Docket No: A-2023-3039900

**Pennsylvania-American Water Company Responses to the
Bureau of Technical Utility Services Deficiencies – August 31, 2023**

66 Pa. C.S. Section 1329 Application Completeness Review
Pennsylvania-American Water Company – Wastewater Division
Acquisition of Township of Towamencin Wastewater System Assets
at Docket No. A-2023-3039900

Re: Hatfield Township Act 537 Plan Revision

Plate 1
ACT 537 PLANNING AREA

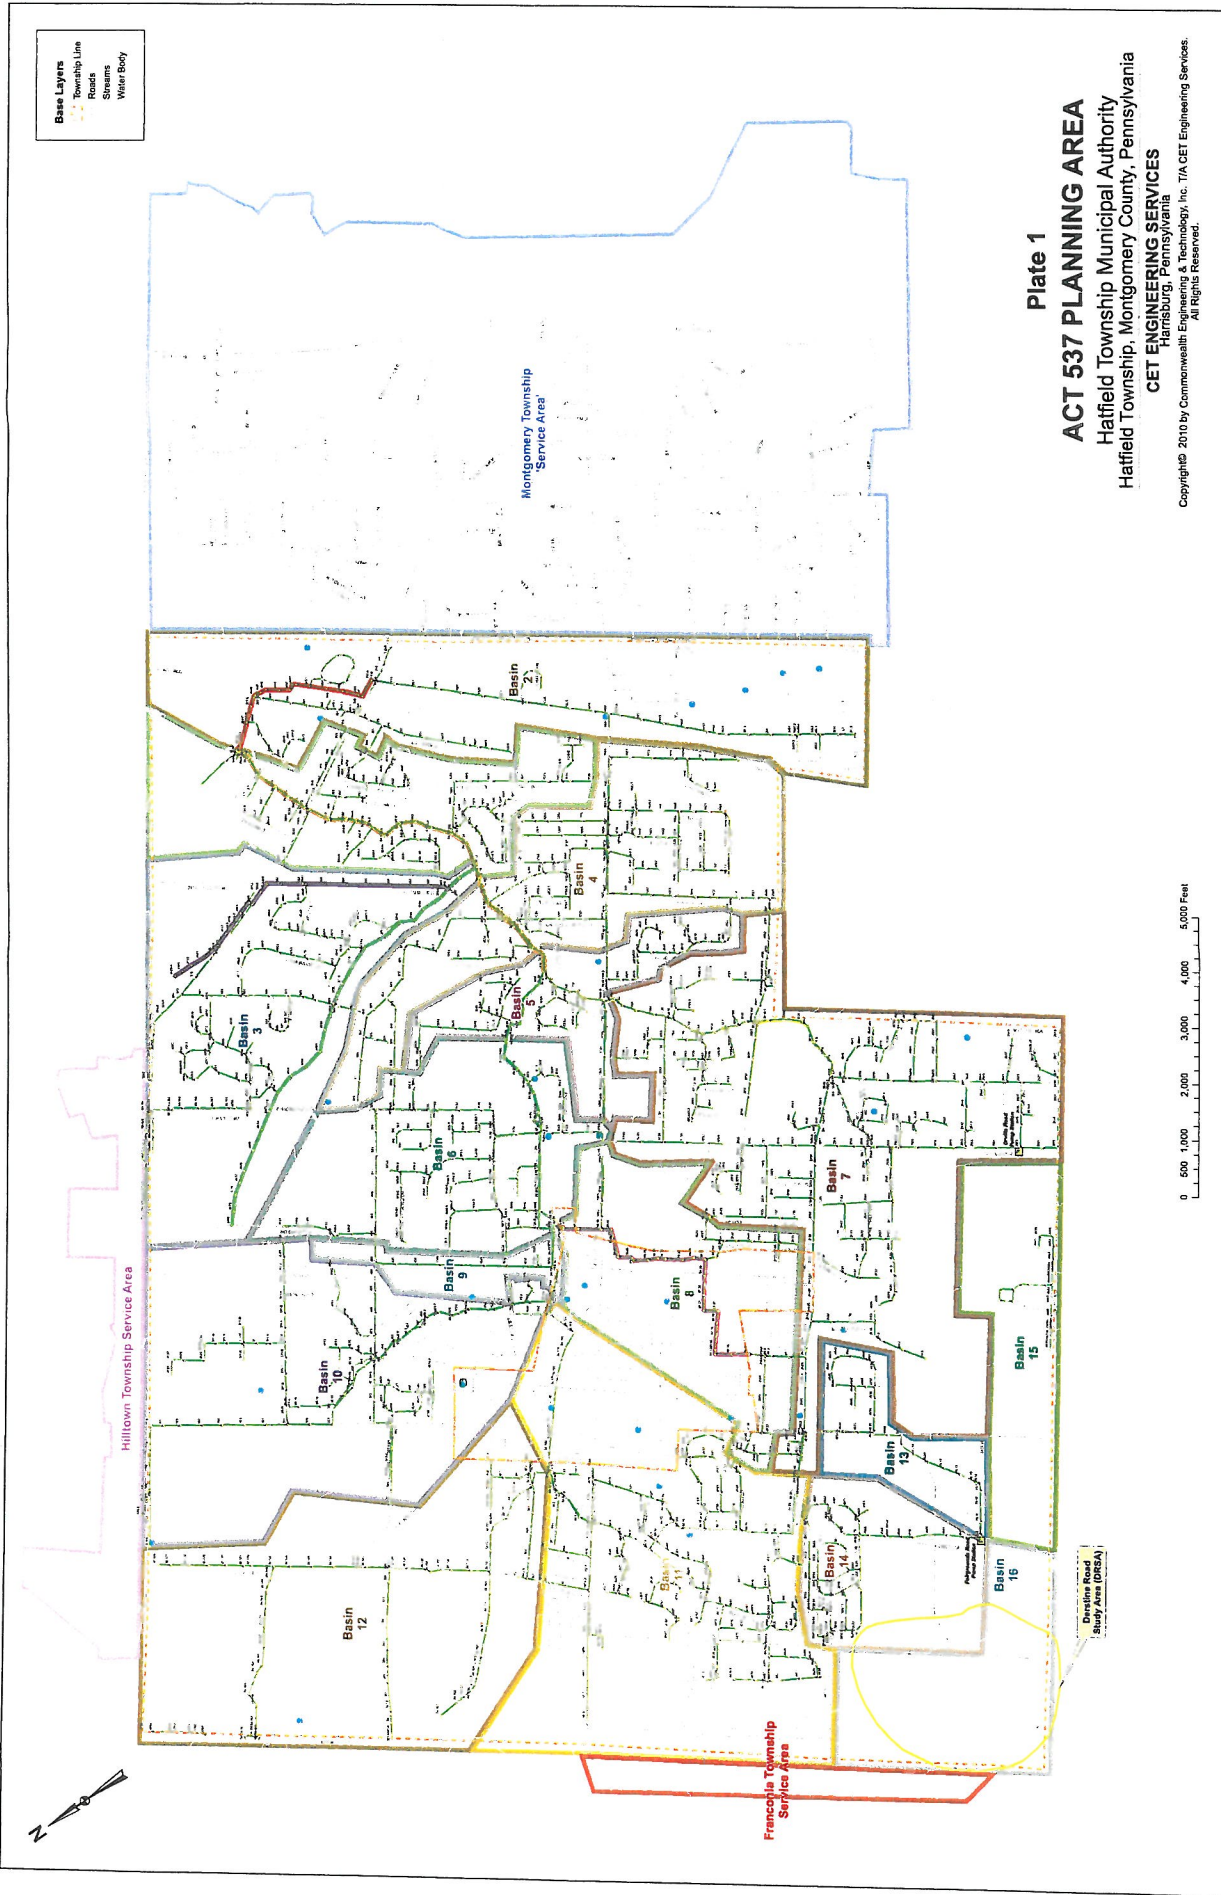
Response 1. Plate 1 has been revised and is attached.
